## Addendum #1

**Project Name:** Nebraska Innovation Campus - 4H Building Renovation & NIC Office Building.  
**Project No.:** 11053  
**Issued:** November 09, 2012  
**Bid Date:** Thursday, November 20th, 2012  
**Bid Opening:** 2:00pm – Private Opening  
**Location:** 728 Q Street Suite C, Lincoln, NE 68508

DOOR 1102.2,

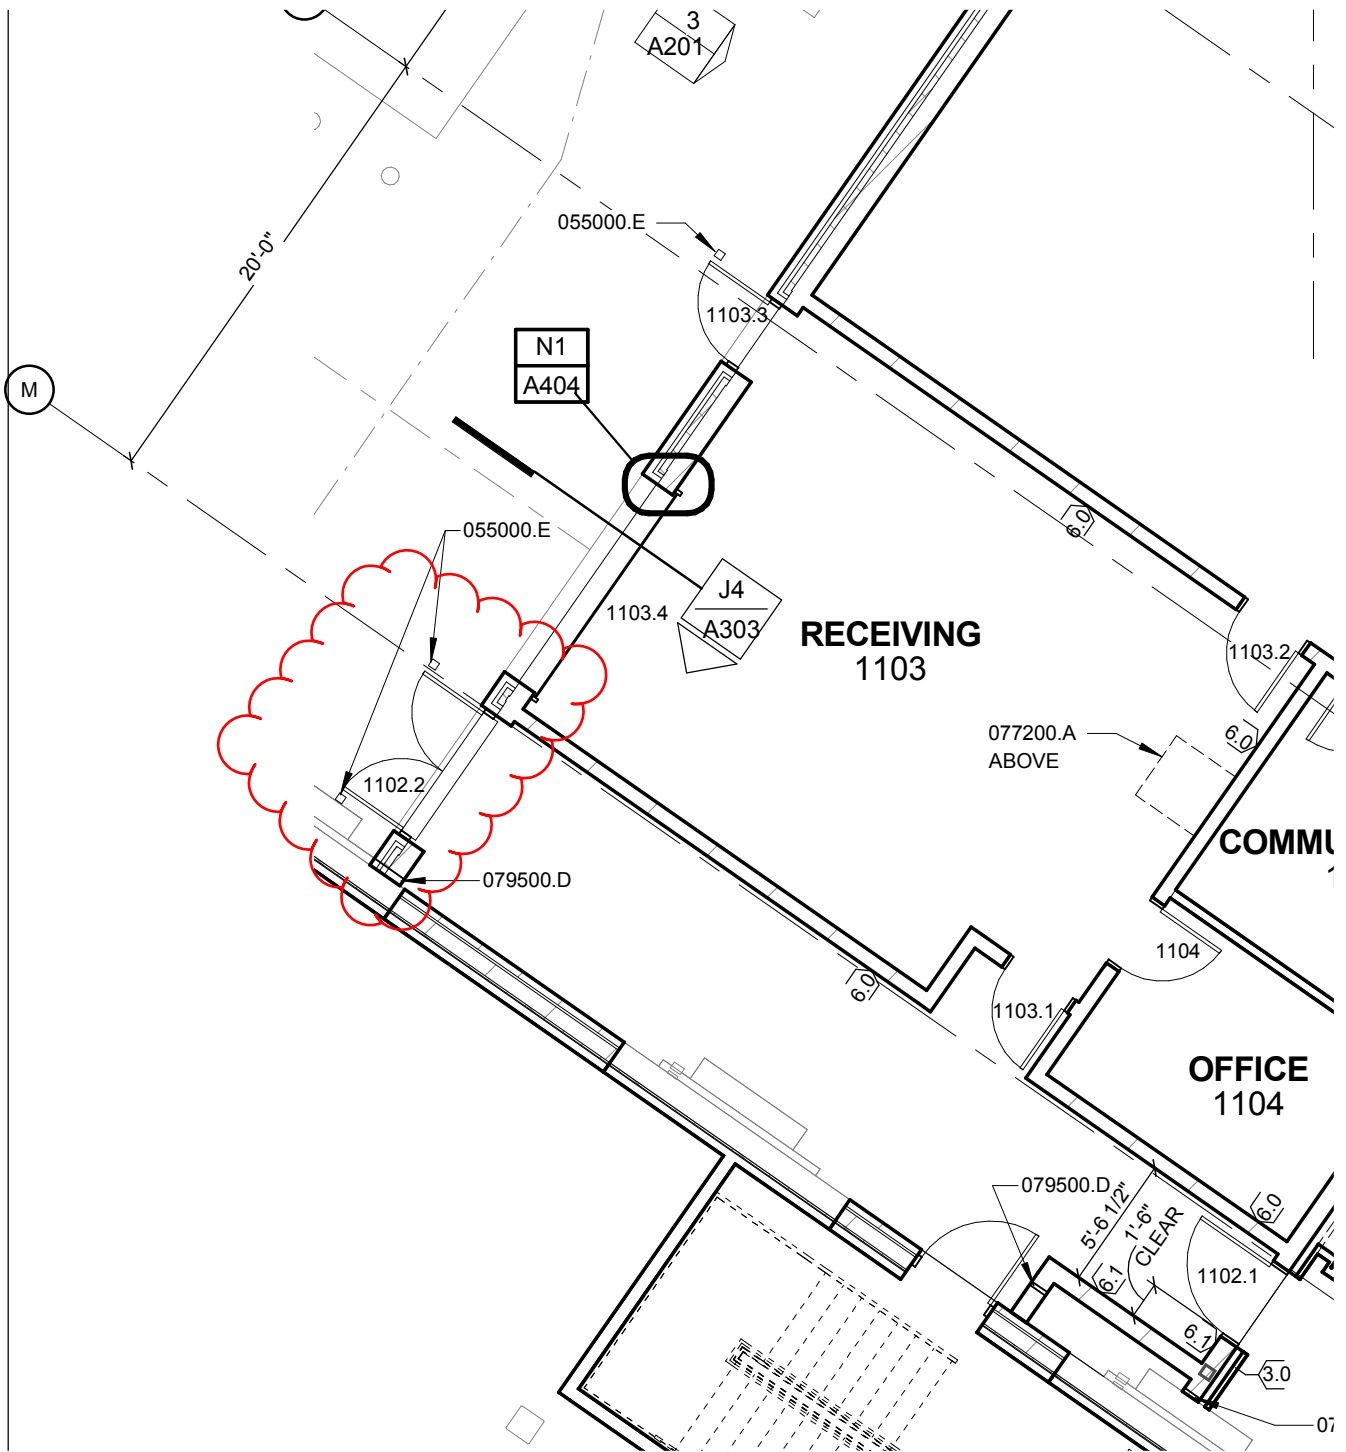
- a. Refer to the Door Schedule: Door 123A.1, and door 125A.1, change the Hardware set from Hdwr 19 to Hdwr 45.
- b. Refer to the Door Schedule: Change Door 1102.2 from a 4'-0" wide door to a pair of 3'-0" doors.
- c. Refer to the Door Schedule: Change Door 1206 from 3'-0" width to 3'-6" width.
- d. Refer to the Door Schedule: Change Door 1211 from 3'-0" width to 3'-6" width.
- e. Refer to K12 – Hollow Metal Frame Types, HM-03. The glass installed into the hollow metal frame shall provide a 45 minute fire rating.

Reference: A10/A101C  
 Bid Package 02  
**Addendum 01**  
 4H Renovation & NIC Building

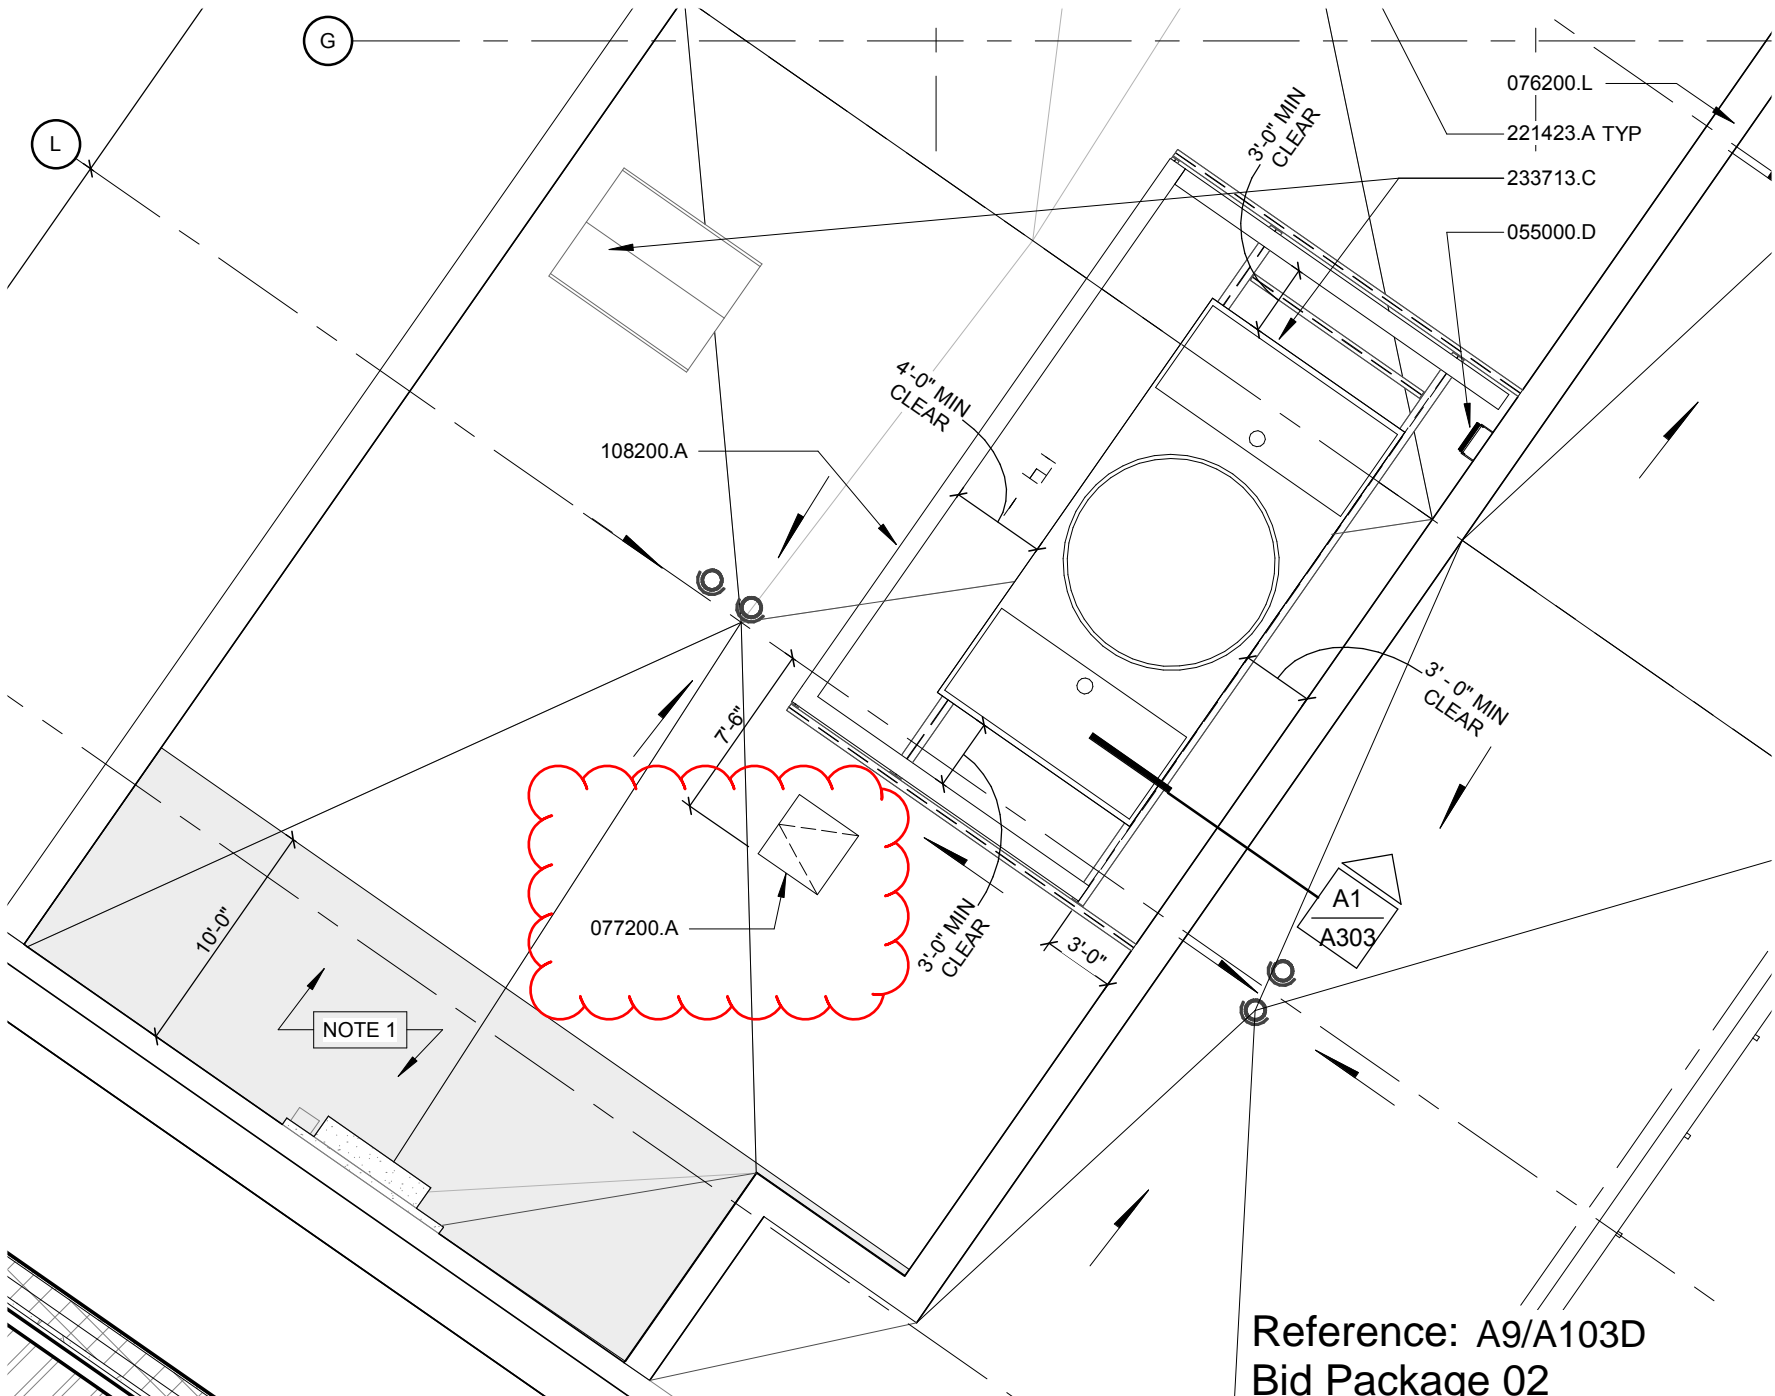
- a. South wall of elevator shaft changed from partition type 4.1 (2hr) to 4.0 (1hr).
- b. Door 1102.2 changed to a Pair of 3'-0" X 8'-0" doors and another bollard 055000.E was added. See attached sketch A10/A101C.

Reference: A9/A103D  
 Bid Package 02  
**Addendum 01**  
 4H Renovation & NIC Building

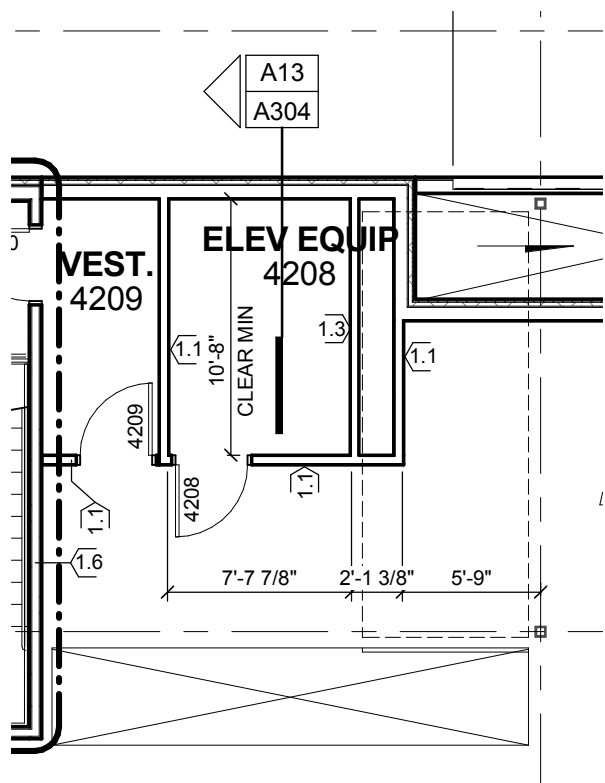
- a. Moved location of roof hatch. See attached sketch, A9/A103D.

Reference: G16/A513  
 Bid Package 02  
**Addendum 01**  
 4H Renovation & NIC Building

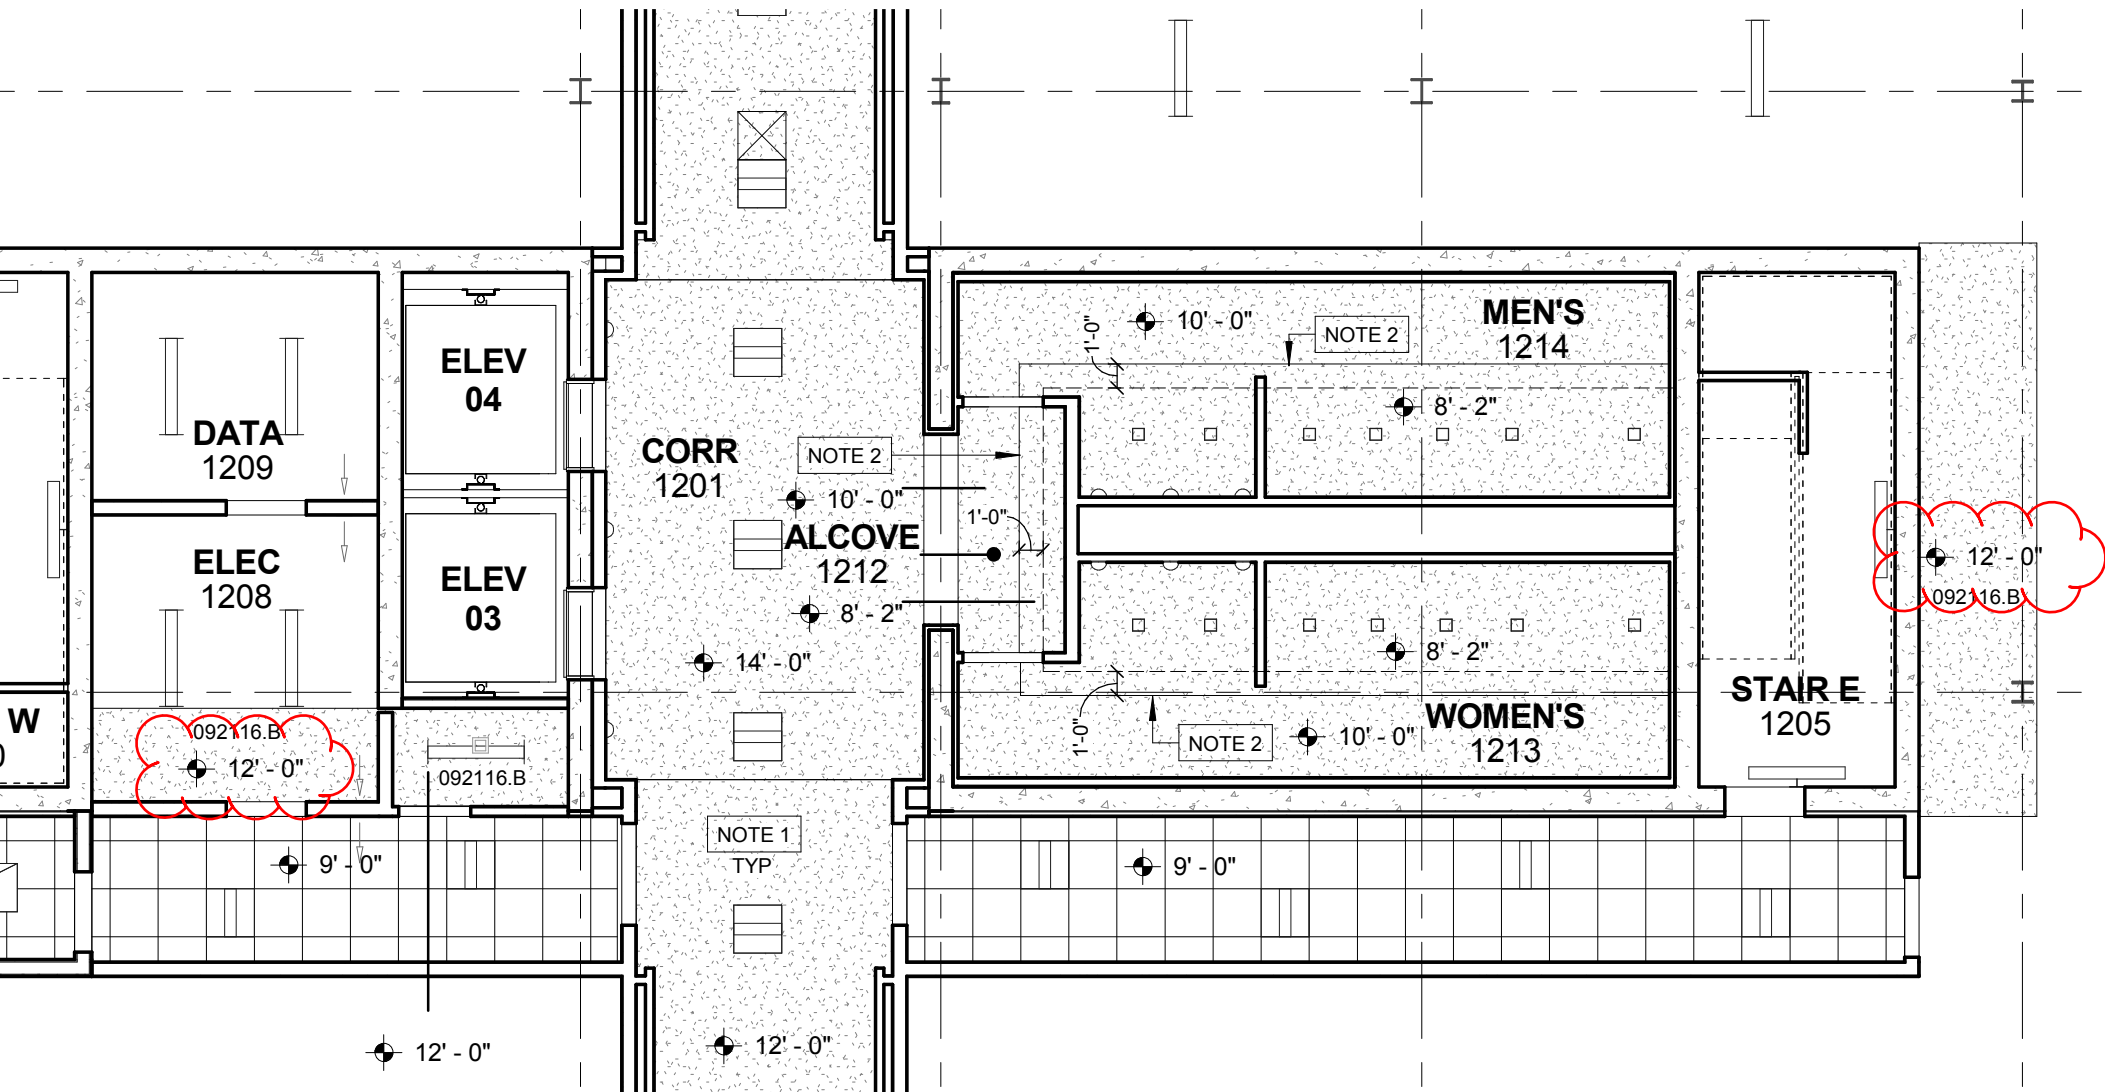
- a. Added wood paneling to Interior Elevation G16/A513 of 2<sup>nd</sup> & 3<sup>rd</sup> Level Elevator Lobby. See attached sketch G16/A513.
- b. Added wood paneling to Interior Elevation D1/A513 of Main Level Elevator Lobby. See attached sketch D1/A513.
- c. Tile pattern added to drawing A1/A513. See attached sketch A1/A513.

Attachment: S1  
 Reference: 5/S501AB  
 Bid Package: 02  
 Addendum: 01

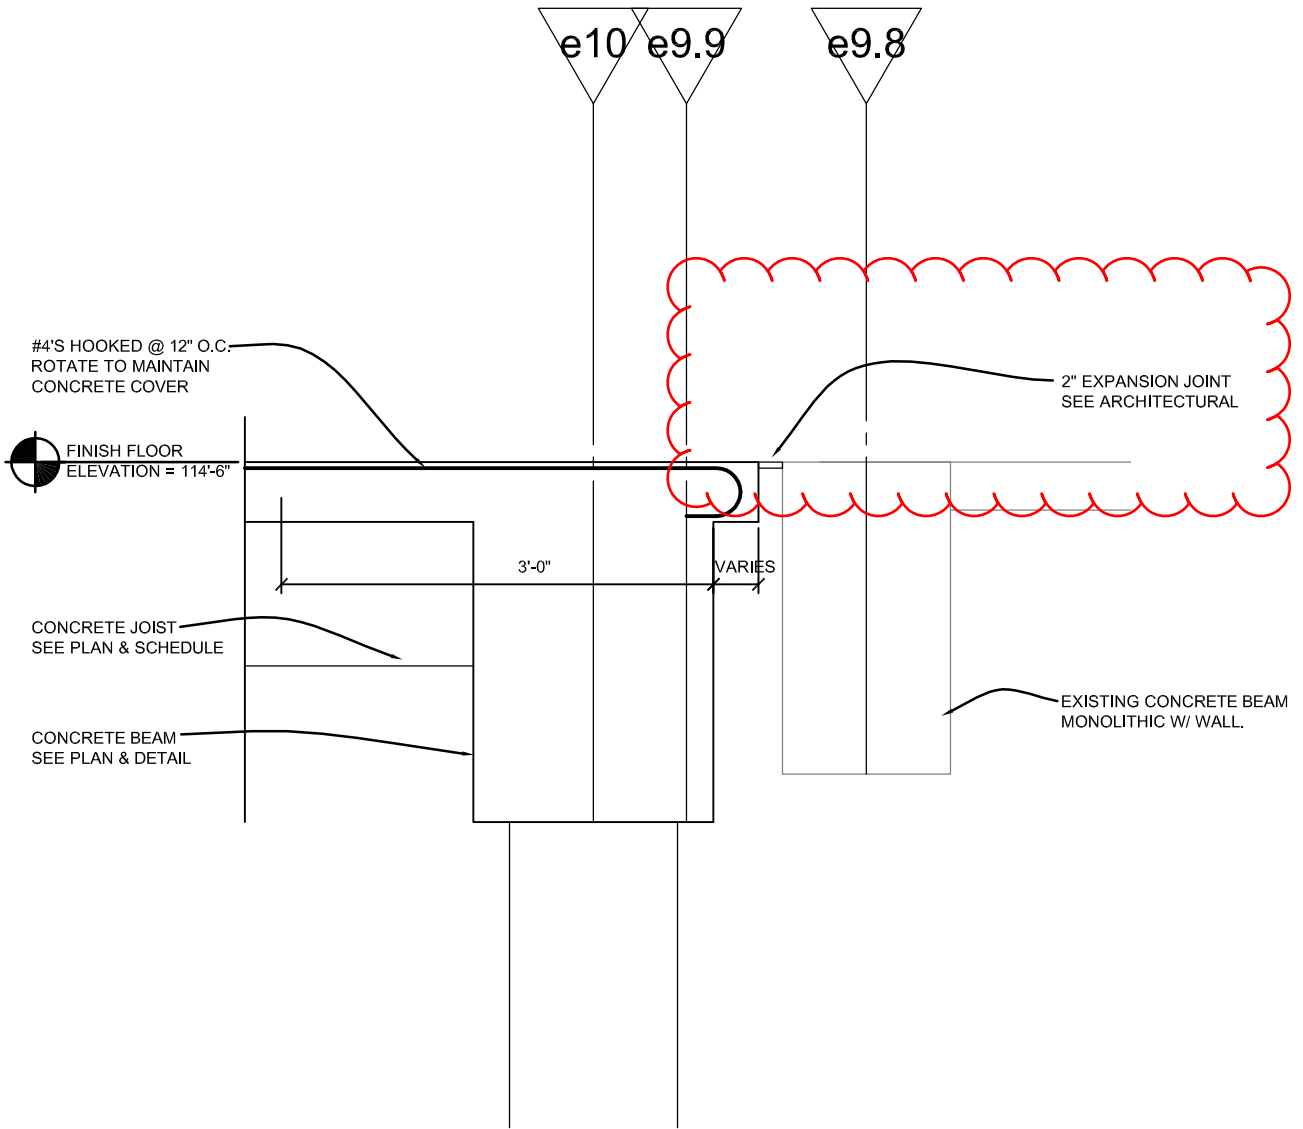
- a. Refer to attached **Sketch S1**. Provide footing extension as shown in detail. This detail applies at 10 locations in Area A (e10-eA.1, e10-eF.9, e11-eA.1, e11-eF.9, e12-eA.1, e12-eF.9, e13-eF.9, e14-eF.9, e15-eA.1, e15-eF.9).

Attachment: S2  
Reference: 7/S504AB  
Bid Package: 02  
Addendum: 01

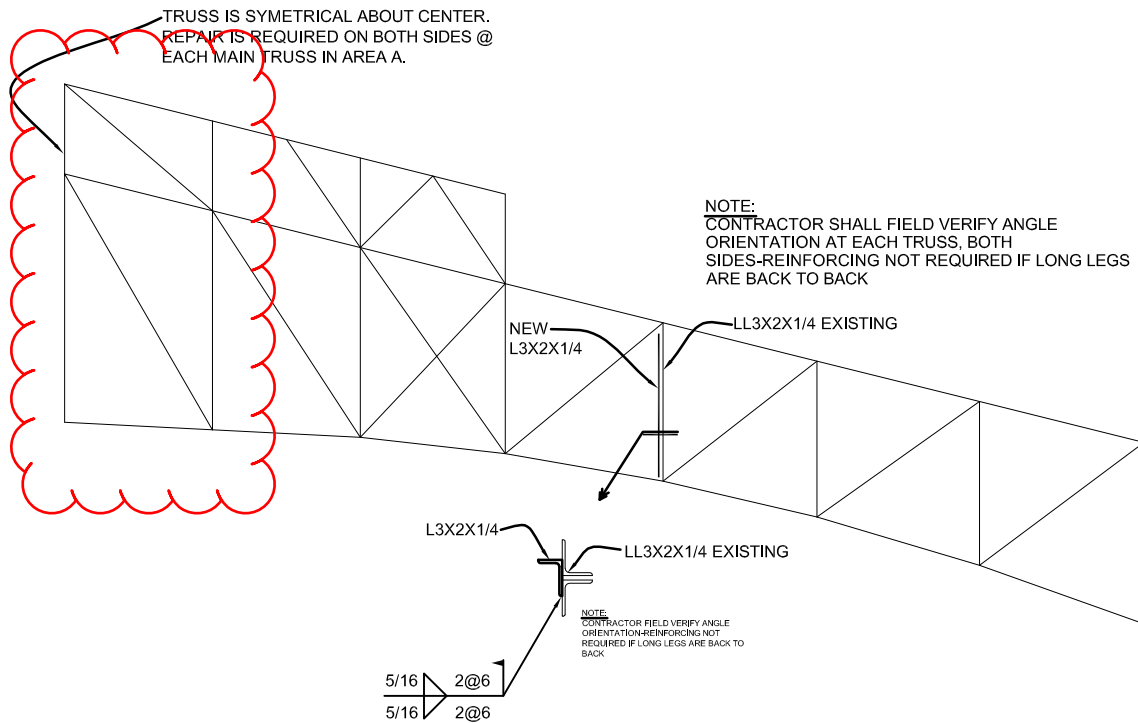
- a. Refer to attached **Sketch S2**. Provide 2" expansion joint as shown. Refer to architectural drawings for more information.

Attachment: S4  
Reference: 14/S502CD  
Bid Package: 02  
Addendum: 01

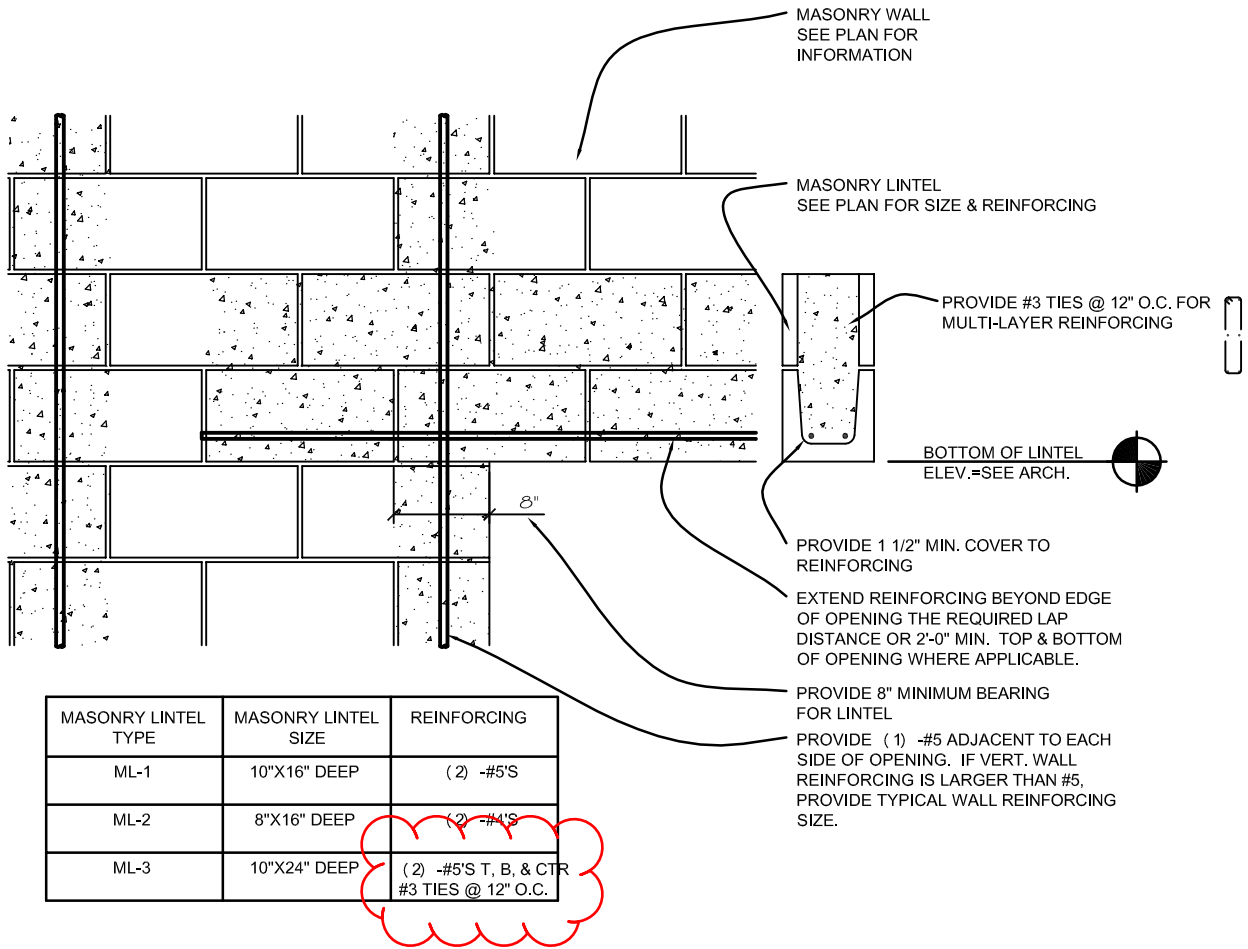
- a. Refer to attached **Sketch S4**. Note the addition of gussets to the detail.

Attachment: S5  
Reference: 5/S001CD  
Bid Package: 02  
Addendum: 01

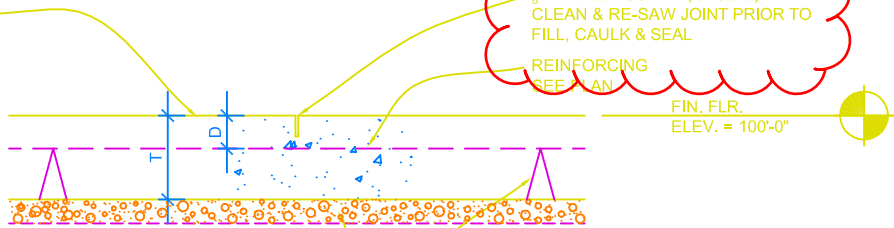
- a. Refer to attached **Sketch S5**. Reinforcing for lintel type ML3 has been added to the schedule.
